RS-08-071

Braidwood Station, Units 1 and 2
Facility Operating License Nos. NPF-72 and NPF-77
NRC Docket Nos. STN 50-456 and STN 50-457

Byron Station, Units 1 and 2
Facility Operating License Nos. NPF-37 and NPF-66
NRC Docket Nos. STN 50-454 and STN 50-455

Subject: License Amendment Request to Revise Emergency Diesel Generator Start Time Surveillance Requirements

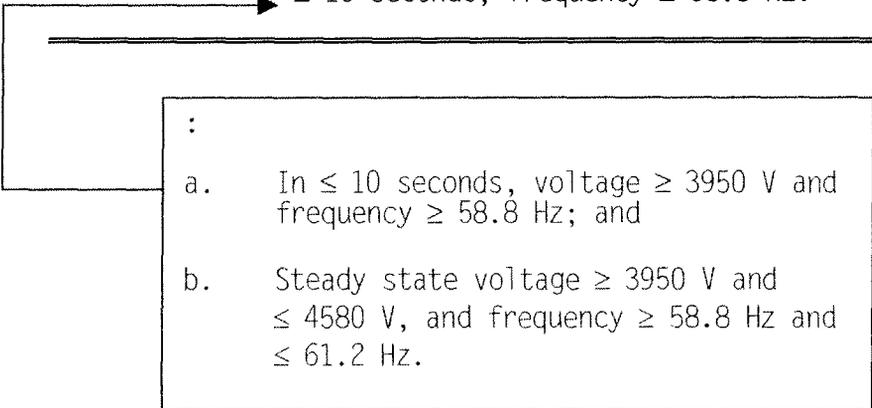
SURVEILLANCE	FREQUENCY
<p>SR 3.8.1.15 -----NOTES-----</p> <ol style="list-style-type: none"> 1. This Surveillance shall be performed within 5 minutes of shutting down the DG after the DG has operated ≥ 2 hours loaded ≥ 4950 kW and ≤ 5500 kW or until operating temperature has stabilized. 2. Momentary transients outside of load range do not invalidate this test. <p>-----</p> <p>Verify each DG starts and achieves in in ≤ 10 seconds voltage ≥ 3950 V and ≤ 4580 V, and frequency ≥ 58.8 Hz and ≤ 61.2 Hz.</p>	<p>18 months</p>
<p>SR 3.8.1.16 -----NOTE-----</p> <p>This Surveillance shall not be performed in MODE 1, 2, 3, or 4.</p> <p>-----</p> <p>Verify each DG:</p> <ol style="list-style-type: none"> a. Synchronizes with offsite power source while loaded with emergency loads upon a simulated restoration of offsite power; b. Transfers loads to offsite power source; and c. Returns to ready-to-load operation. 	<p>18 months</p>

- :
- a. In ≤ 10 seconds, voltage ≥ 3950 V and frequency ≥ 58.8 Hz; and
 - b. Steady state voltage ≥ 3950 V and ≤ 4580 V, and frequency ≥ 58.8 Hz and ≤ 61.2 Hz.

- b. Steady state voltage ≥ 3950 V and ≤ 4580 V, and frequency ≥ 58.8 Hz and ≤ 61.2 Hz."

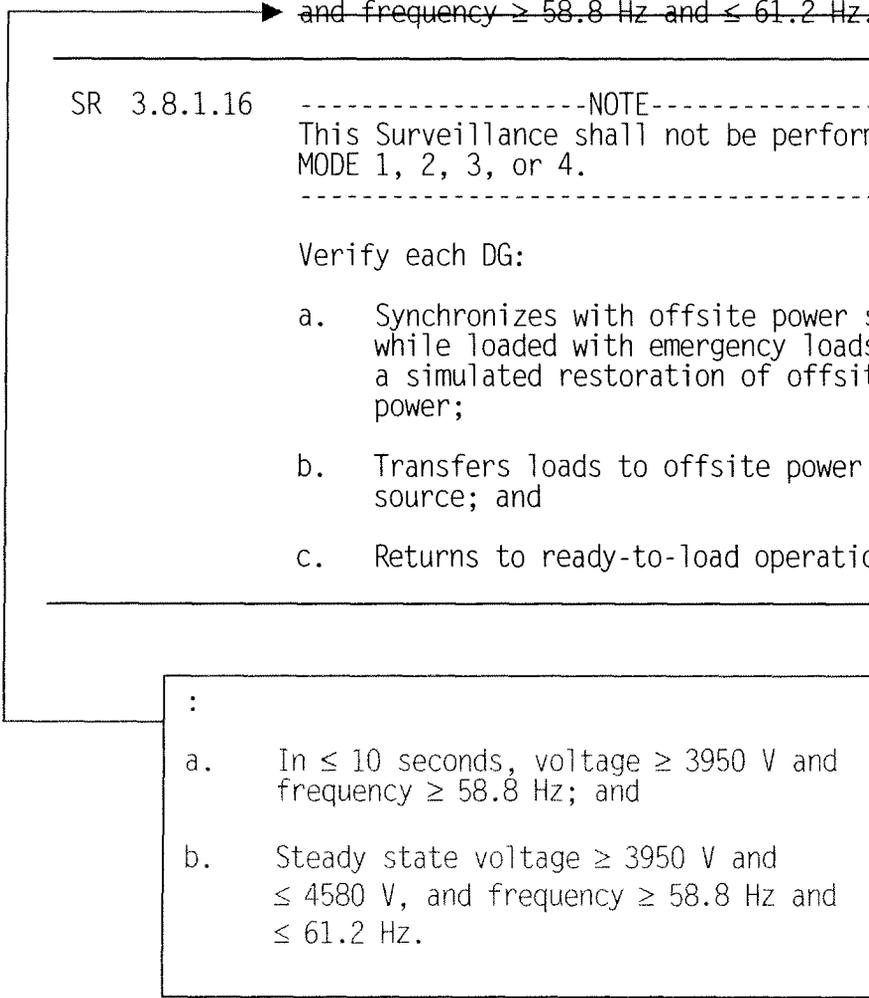
SURVEILLANCE	FREQUENCY
<p>SR 3.8.1.15 -----NOTES-----</p> <ol style="list-style-type: none"> 1. This Surveillance shall be performed within 5 minutes of shutting down the DG after the DG has operated ≥ 2 hours loaded ≥ 4950 kW and ≤ 5500 kW or until operating temperature has stabilized. 2. Momentary transients outside of load range do not invalidate this test. <p>-----</p> <p>Verify each DG starts and achieves in in ≤ 10 seconds voltage ≥ 3950 V and ≤ 4580 V, and frequency ≥ 58.8 Hz and ≤ 61.2 Hz.</p>	<p>18 months</p>
<p>SR 3.8.1.16 -----NOTE-----</p> <p>This Surveillance shall not be performed in MODE 1, 2, 3, or 4.</p> <p>-----</p> <p>Verify each DG:</p> <ol style="list-style-type: none"> a. Synchronizes with offsite power source while loaded with emergency loads upon a simulated restoration of offsite power; b. Transfers loads to offsite power source; and c. Returns to ready-to-load operation. 	<p>18 months</p>

- a. In ≤ 10 seconds, voltage ≥ 3950 V and
frequency ≥ 58.8 Hz; and
- b. Steady state voltage ≥ 3950 V and
 ≤ 4580 V, and frequency ≥ 58.8 Hz and
 ≤ 61.2 Hz.
